ADDENDUM A

Nebraska Educational Telecommunications (NET)
Lower Level – Office Remodel
1800 N. 33rd Street
Lincoln, Nebraska
RDG Project No. 2012.196.00, File 35.1

RDG Planning & Design
900 Farnam on the Mall, Suite 100
Omaha, NE 68102-5089
(402) 392-0133

PROJECT NO.	DATE	DRAWING REFERENCED:	M02.01
20123238	04-19-2013	ADDENDUM NO.:	1
			SKETCH MS-3

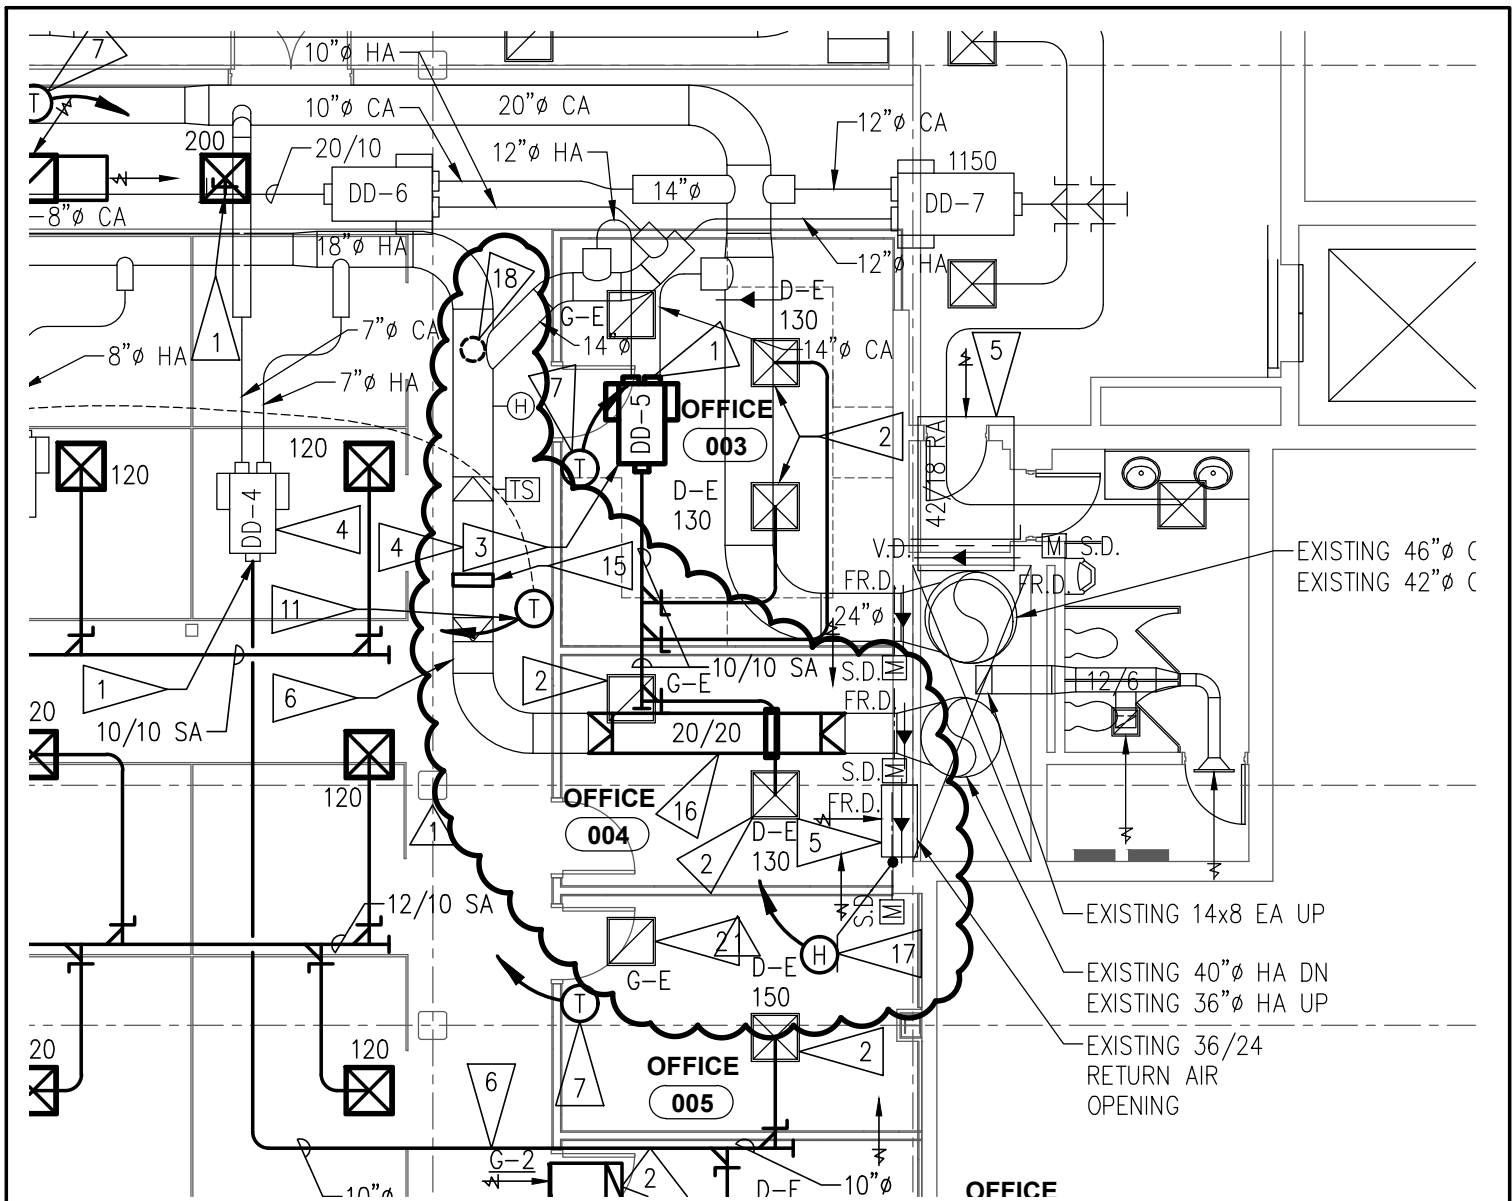
Sheet M02.01 - Lower Level HVAC: Install the humidifier ductwork and humidistat as clouded on Mechanical Sketch Sheet MS-3.

PER BID ALTERNATE NO.3, PATCH THE EXISTING 20"x20" HA DUCT WHERE THE EXISTING HUMIDIFIER IS REMOVED FROM. DUCTWORK IS OPERATED WITH 3" W.C. STATIC PRESSURE.
-

PER BID ALTERNATE NO.3, INSTALL NEW 20"x20" HA DUCT AND TRANSITIONS AS SHOWN FOR THE RELOCATED HUMIDIFIER, SEE SHEET M01.01. DUCTWORK IS OPERATED WITH 3" W.C. STATIC PRESSURE.
-

PER BID ALTERNATE NO.3, INSTALL NEW NON-OCCUPANT ADJUSTABLE BAS INTEGRATED HUMIDISTAT ABOVE THE CEILING NEAR THE EXISTING RETURN AIR OPENING. HUMIDISTAT SHALL BE PROVIDED AND INSTALLED BY THE TEMPERATURE CONTROL CONTRACTOR. ALLOW FOR RH MONITORING AND SETPOINT ADJUSTMENT VIA THE BAS.
-

PER BID ALTERNATE NO.3, INSTALL DUCTWORK TEE IN BOTTOM OF EXISTING DUCT, SEE DETAIL 7/M03.01.

7
M03.01

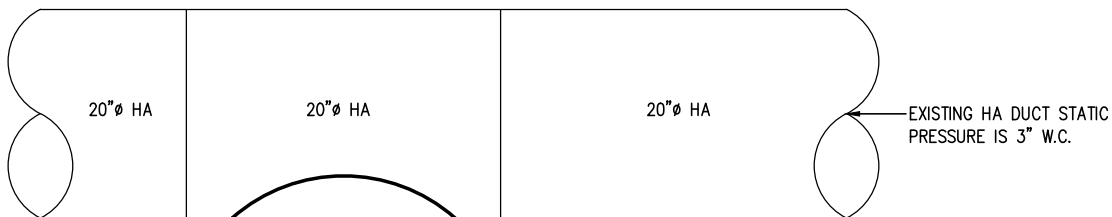
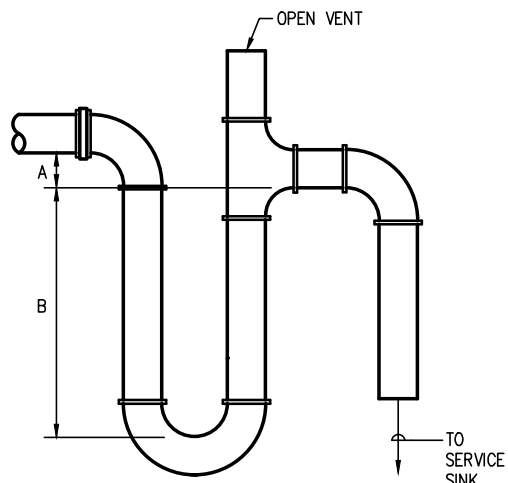
B. Add Detail 7/M03.01 – Ductwork Drain Detail as clouded on Mechanical Sketch Sheet MS-4.

INSTALL A ROUND BULL-NOSE TEE HA DUCTWORK FITTING WITH THE TEE POINTING DOWN AND CAPPED WATERTIGHT

CONNECT CD PIPING TO CENTER OF DUCTWORK, CAP AND SEAL WATERTIGHT

INSTALL TEE WITH AS LARGE OF A DIAMETER AS POSSIBLE, FIELD VERIFY

A = 1" (MIN)
B = EQUAL TO DUCT STATIC PRESSURE x 1.25
